Proposed Revisions to a Standard Plans Index

Index Number: 700-090

Sheet Number (s): 4 of 5

Index Title: DYNAMIC MESSAGE SIGN WALK-IN

SHEET
4 of 5

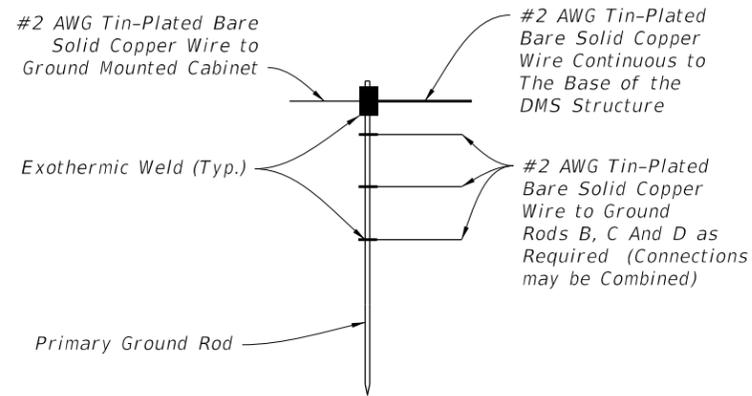
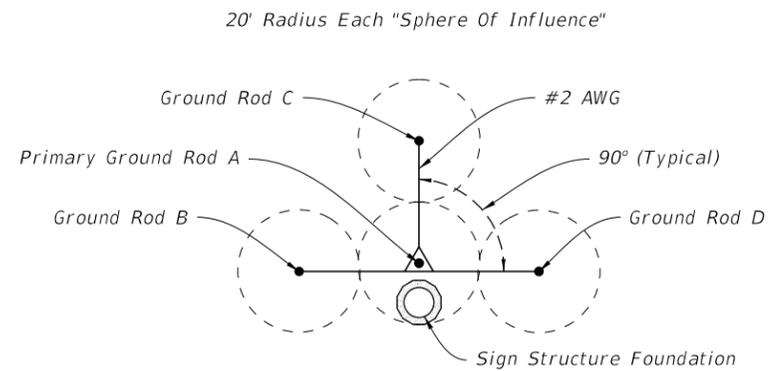
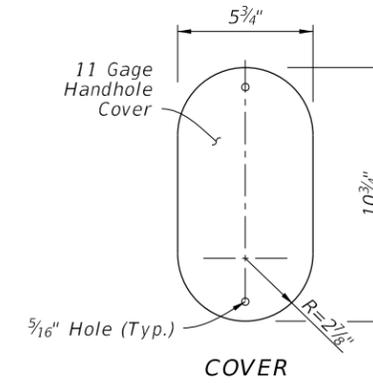
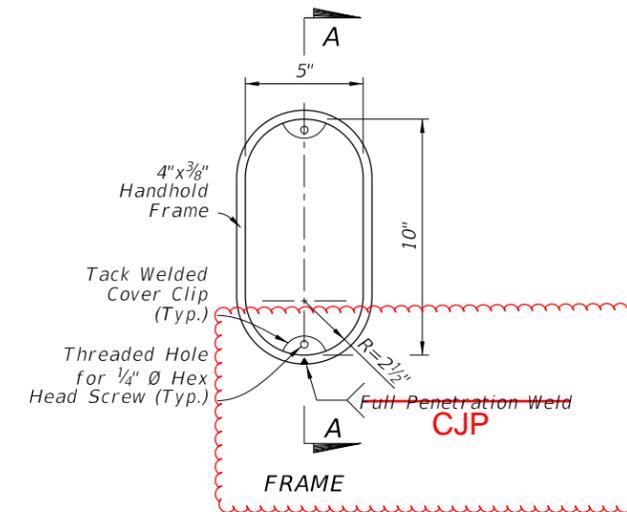
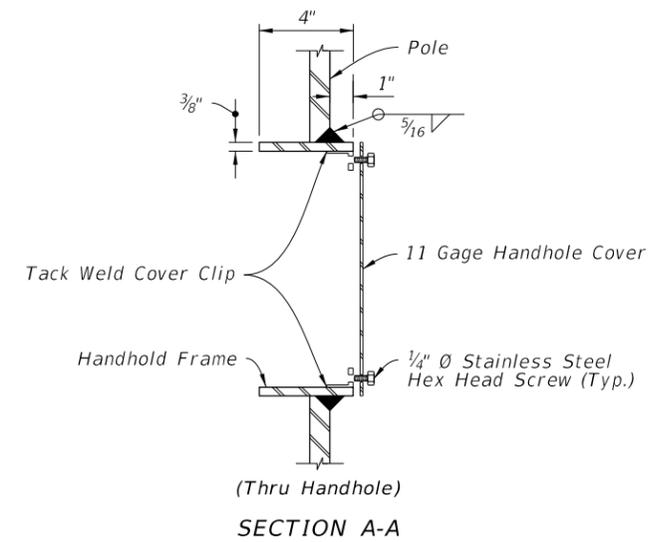
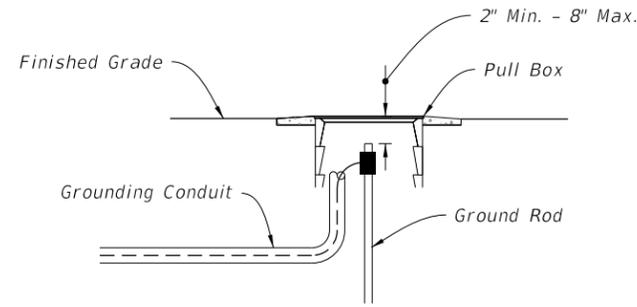
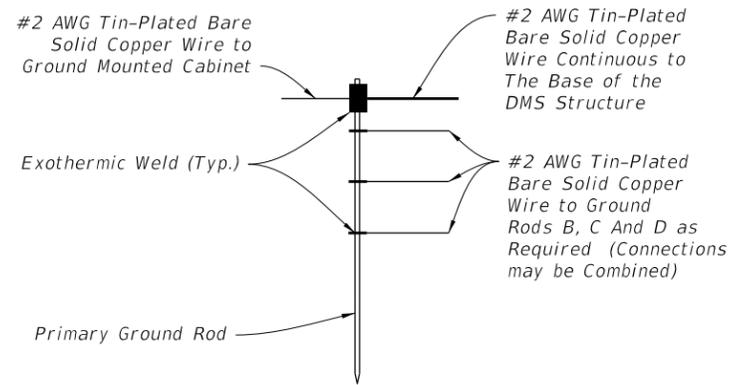
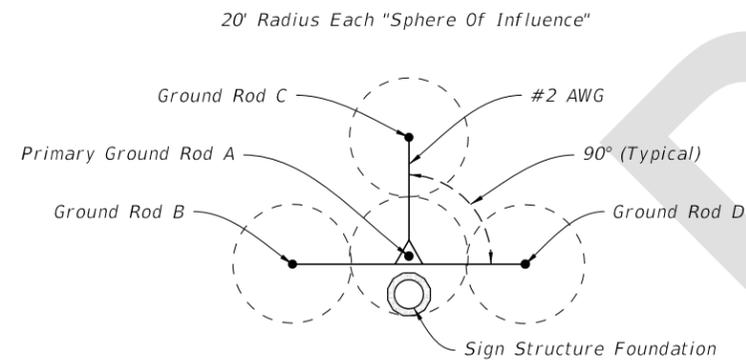
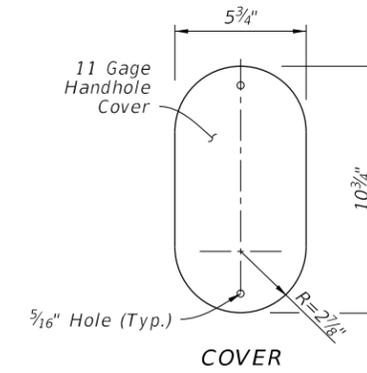
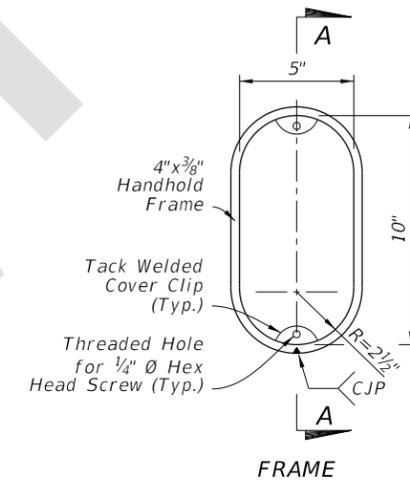
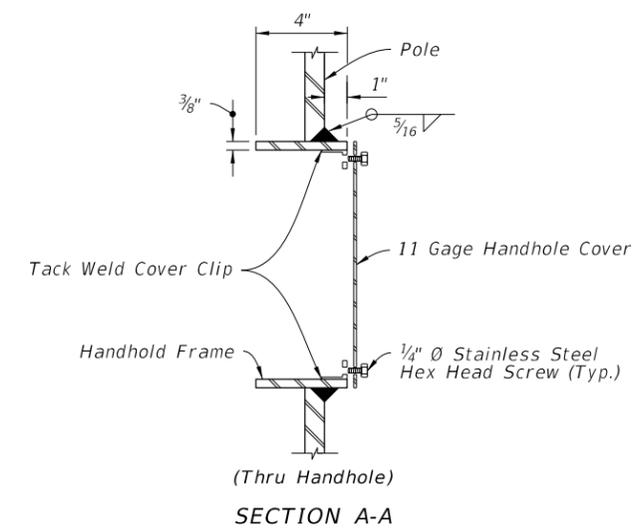
Sheet 4: Changed weld detail to say "CJP."

Sheet 4: Changing non-standard language to standard language consistent with AWS.

Spec 460 will accompany the revision.
